Road Safety Audit Report

Stage 1/2 Completion of Detail Design; and

Proposed Highway Works to form a Continuous Footway at the northern access to Havant & South Downs College Barncroft Way Havant

Report Title:	Stage 1/2 Road Safety Audit
Date:	August 2025
Document reference and revision:	RSA-25-085-2
Prepared by:	Fenley Road Safety Limited
County Highway Authority:	Hampshire County Council
Design Organisation:	Scott White and Hookins
Project Sponsor:	Landmark Development Consultants

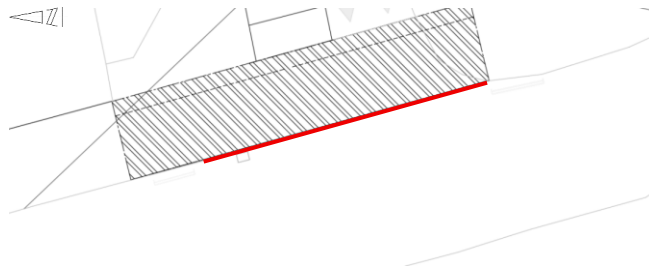
B.1	LOCAL ALIGNMENT
	<i>No Road Safety Concerns regarding LOCAL ALIGNMENT have been raised at this stage</i>
B.2	GENERAL
B.2.1	PROBLEM
Location:	Barncroft Way
Summary:	Edge of carriageway may not generate a smooth alignment
Acc Type:	Vehicle loss of control type collision
The existing northern access to HSDC Havant is just circa 3.5 metres wide and taken off Barncroft Way at a bellmouth that accommodates 6 metre radii. The access is formed in a concrete surface that meets the tangent of each radii and allows for a smooth edge of carriageway. The proposals include highway works to remove the existing bellmouth and provide a vehicular crossover to allow access to a 7 metre carriageway that allows for two-way traffic. The continuous footway and access road are to be provided at existing levels and therefore a ramp is to be provided to the east, immediately adjacent to give-way markings that highlight the need for motorists to slow and give priority to pedestrians. The scheme drawings illustrate the area of the 3.7 metre wide continuous footway and identifies that the western edge, along Barncroft Way, will not meet the tangent of the southern radius. The Audit Team have concerns that this does not generate a smooth edge of carriageway which could lead to loss of control type collisions should a motorist suddenly become aware of the and swerve.

RECOMMENDATION:	
It is recommended that the proposed works allow for a smooth edge of carriageway.	
Location Plan:  	
B.2.2	PROBLEM
Location:	Barncroft Way
Summary:	Proposed ACO drain is likely to become blocked by debris
Acc Type:	Vehicle sideswipe type collision
Barncroft Way is mostly cambered which forces surface water to fall towards the channels where it drains through a network of road gullies. The proposals include the removal of an existing road gully that is situated immediately to the north of the existing northern access to HSDC Havant and

Stage 1/2 Road Safety Audit (RSA) Decision Log					
Item	RSA Summary	RSA Recommendation	Design Organisation	Overseeing Organisation Response	Agreed RSA Action
B.2.1	Edge of carriageway may not generate a smooth alignment	It is recommended that the proposed works allow for a smooth edge of carriageway.	Accept – The scheme references that the proposed continuous footway is to be provided in accordance with the example on page 18 of TG10 published by Hampshire County Council. The standard detail identifies that PC3 kerbs are to be provided along the edge of the carriageway. These will replace the corner radii and meet the existing kerblines generating a smooth alignment along the edge of carriageway.		
B.2.2	Proposed ACO drain is likely to become blocked by debris	It is recommended that the linear drain is replaced with strategically located road gullies.	Accept – The proposals will not adjust the existing levels of Barncroft Way and therefore the existing road gully will be retained. This existing road gully is situated outside of the proposed vehicular crossover, adjacent to the transition kerbs, according to the topographical survey. The grate should therefore not be situated along the desire line of a cyclist turning left onto the proposed vehicular crossover, however, if considered necessary the grate can be exchanged for a cyclist friendly type.

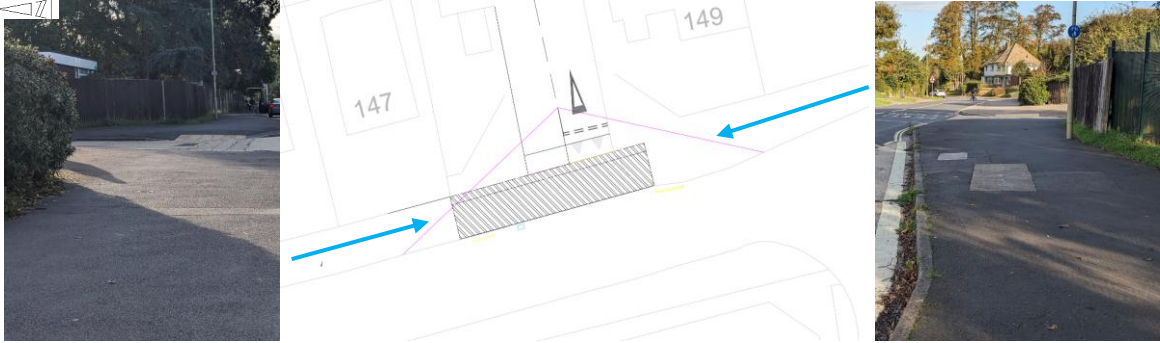
replacement with an ACO channel drain. Whilst the surface area of a linear drains will generally exceed that of a road gully and therefore could drain an excess amount of surface water, the Audit Team have concerns that the debris that collects within a channel could block a linear drains due to the narrow nature of the grills which could have an impact on the drainage of surface water resulting in ponding and loss of control type collisions.

It is recommended that the linear drain is replaced with strategically located road gullies
